Meeting of Committee 18/3/15 Application 5(3) (iv) Report on Breach of Conditions at Crook Moss Gypsy/Traveller Site

Town and Country Planning (Scotland) Acts
Planning application: 12/00546/FLL
Formation of five permanent gypsy/traveller pitches (partly in retrospect)
Land 300 Metres South East of Fossoway Garage Fossoway

Committee 1st August 2012 Paper 4 (1) (ii) Establishment of Gypsy/Travellers Site at Crook Moss, Crook of Devon

Map 6: Crook of Devon

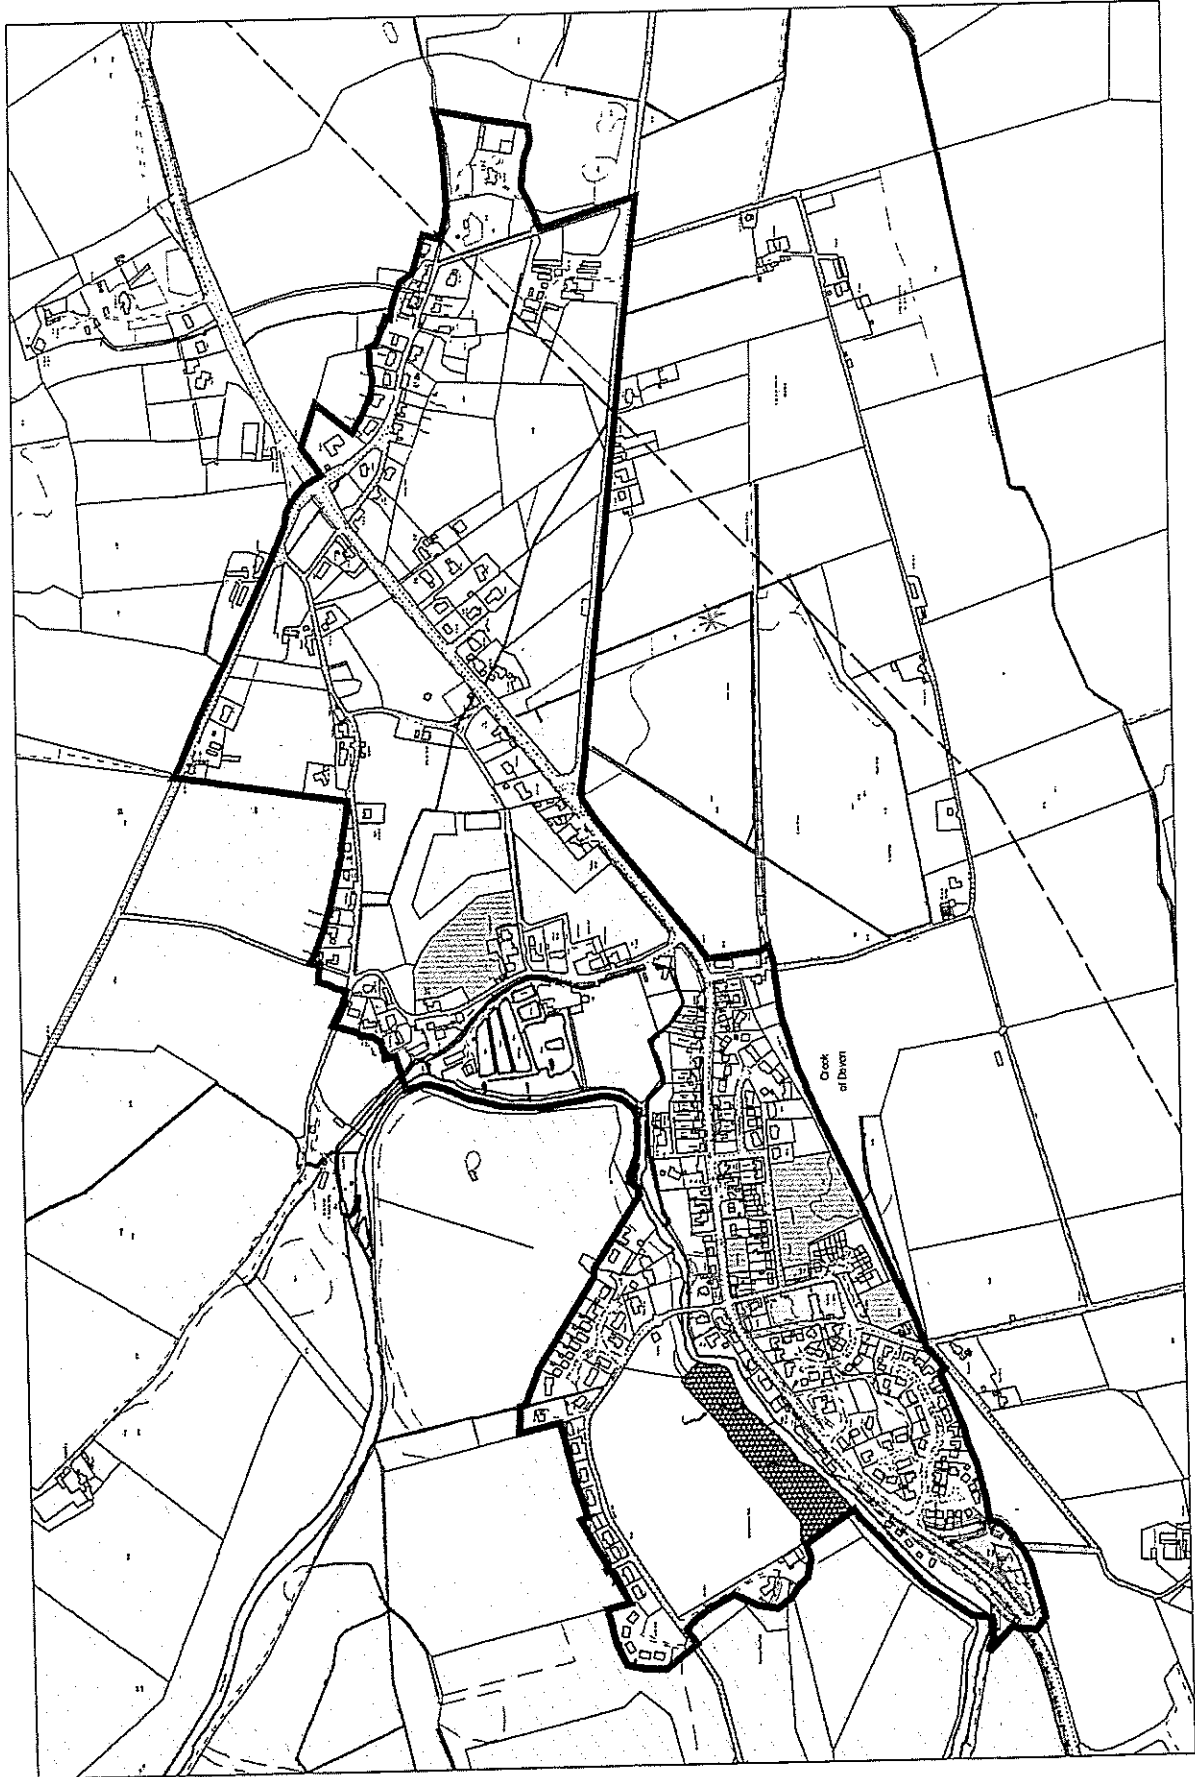
1. Inset Map 6 under Policy 81 (omitted from Report) of Kinross Area Local Plan 2004.
2. Settlement Strategy Landscape Capacity Study Kinross Local Plan Draft Report August 2005 Table 1, Table 5 re Crook Moss Assessment Area CD3 circled on Plan 4 (note the constraints against development).

PLAN 4 CROOK OF DEVON AND DRUM ASSESSMENT AREAS

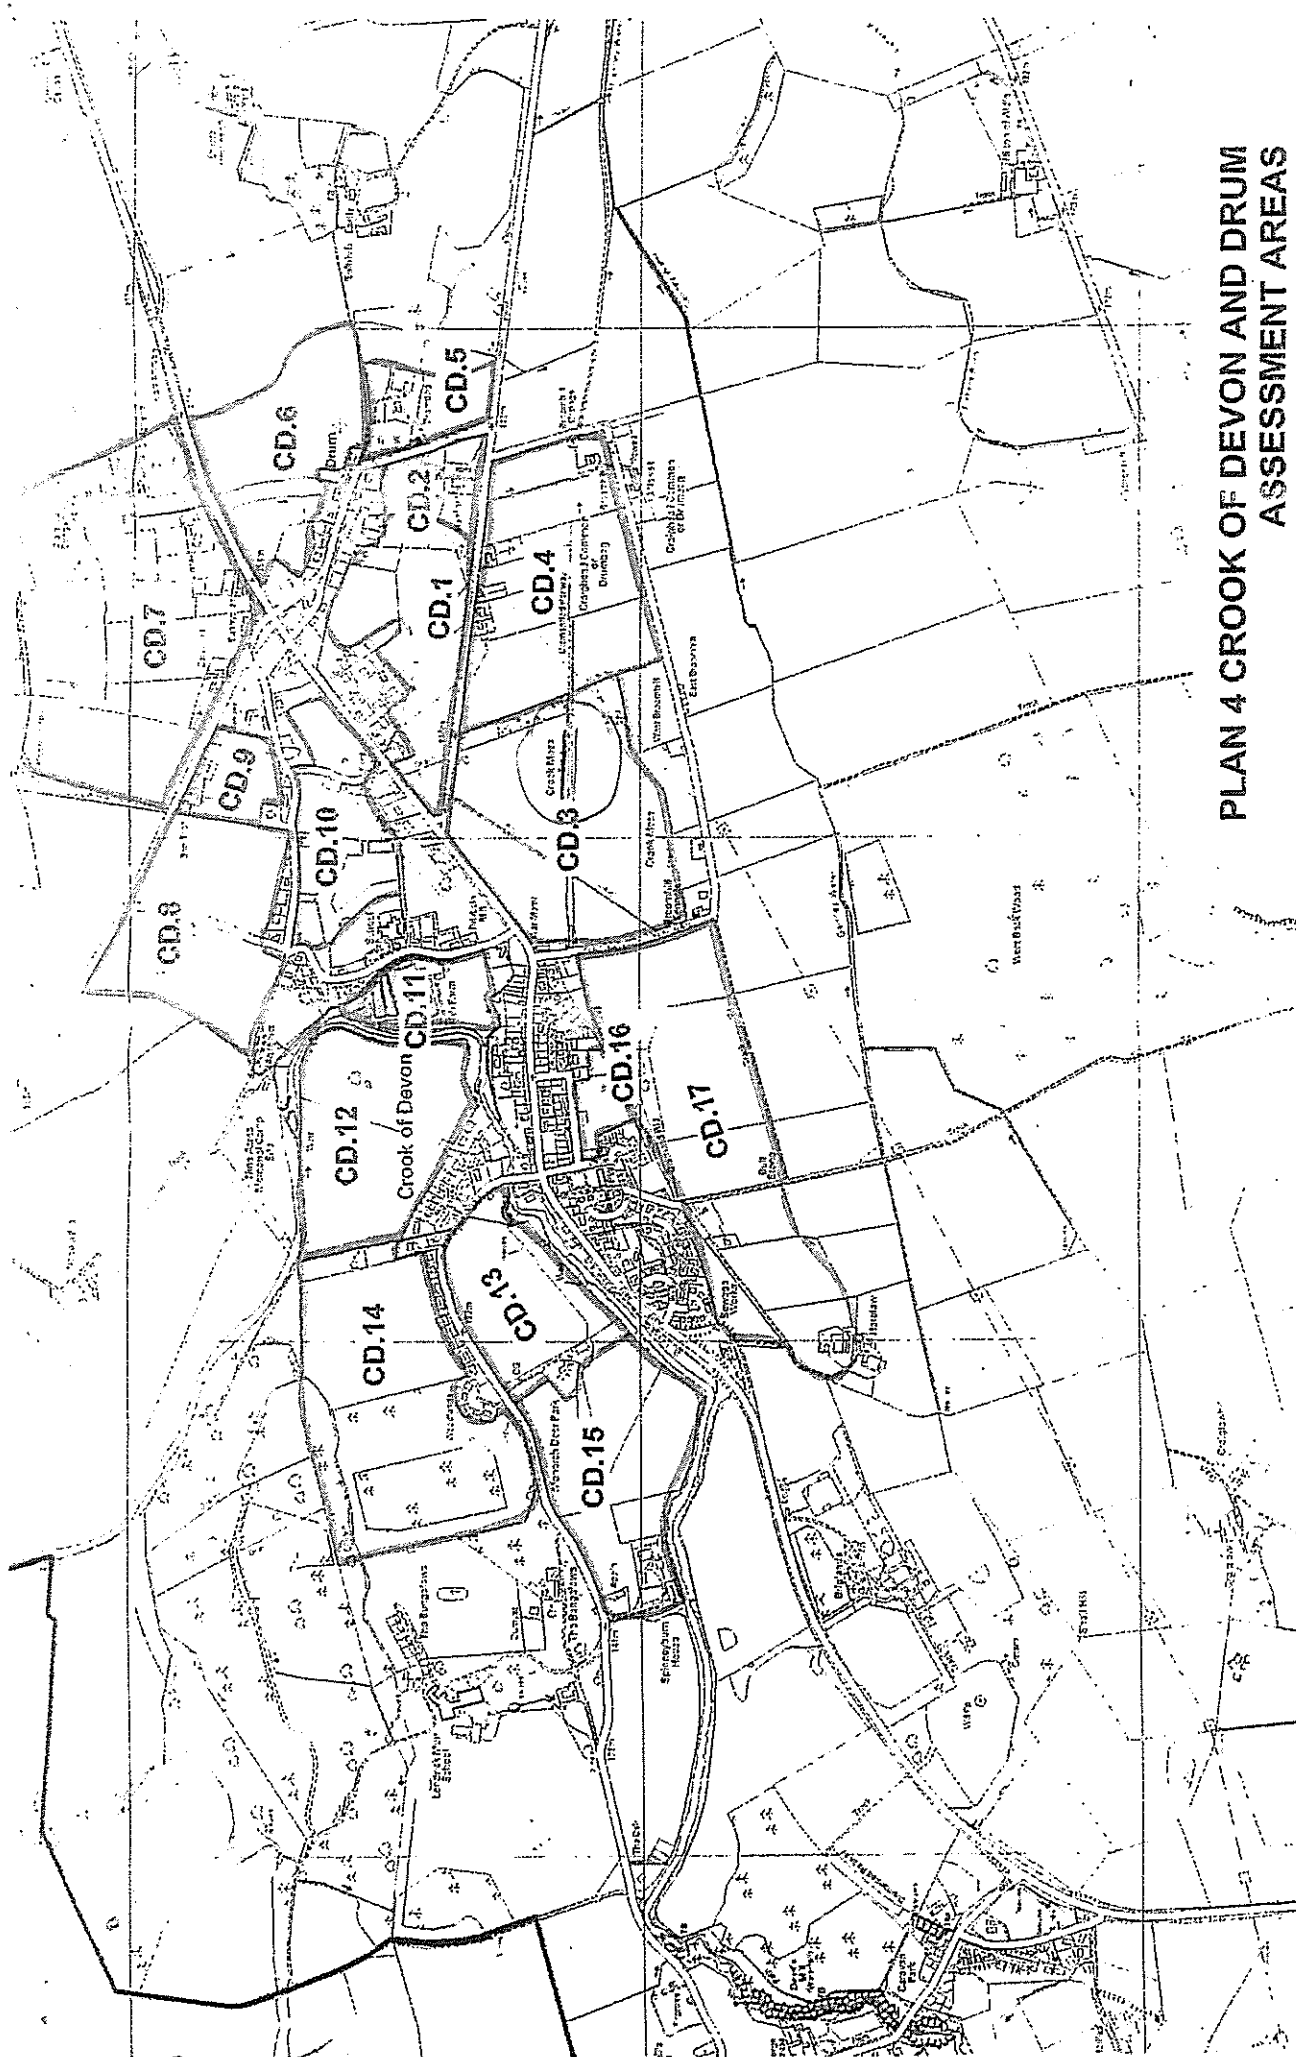
You should note that the community agreed with the landscape capacity study on CD3 as not appropriate for development but disagreed on CD4, because of flood risk.

**PLAN 10 CROOK OF DEVON AND DRUM
ASSESSMENT**

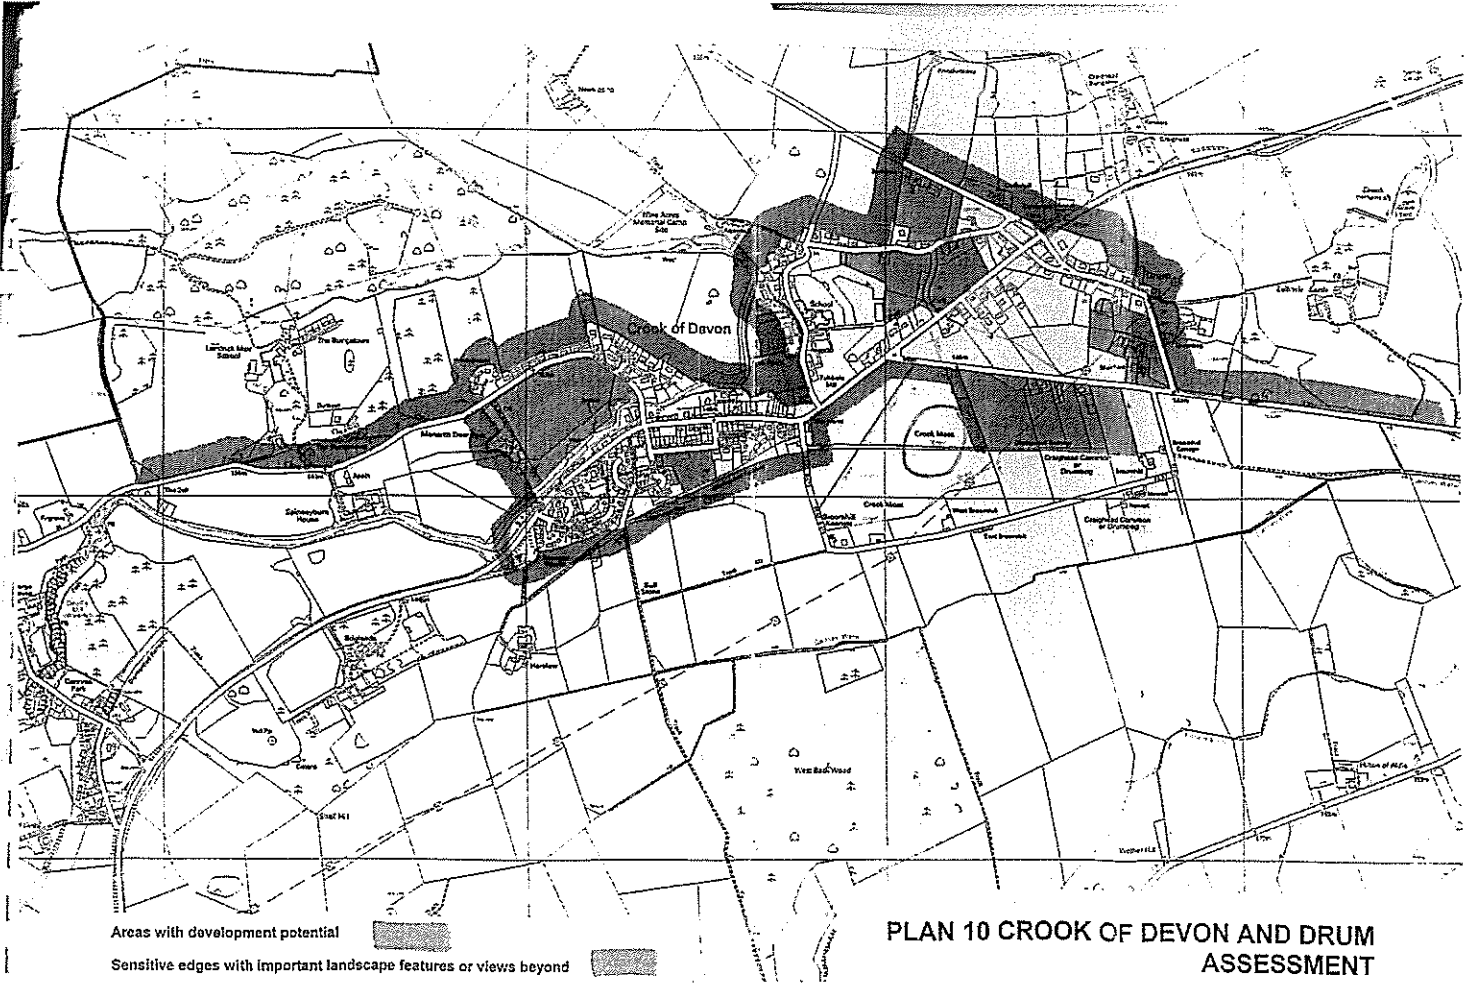
3. Plan 10 Assessment from Landscape Capacity Study March 2005 (note sensitive edges with important landscape features or views beyond at site locus).
4. Slide Map 43 of February 2010 showing submissions towards inclusion in the Local Development Plan Main Issues Report (Crook Moss in Green No 15/9076 – on 11.83 hectare site proposed for community access, forestry, open space and recreation).
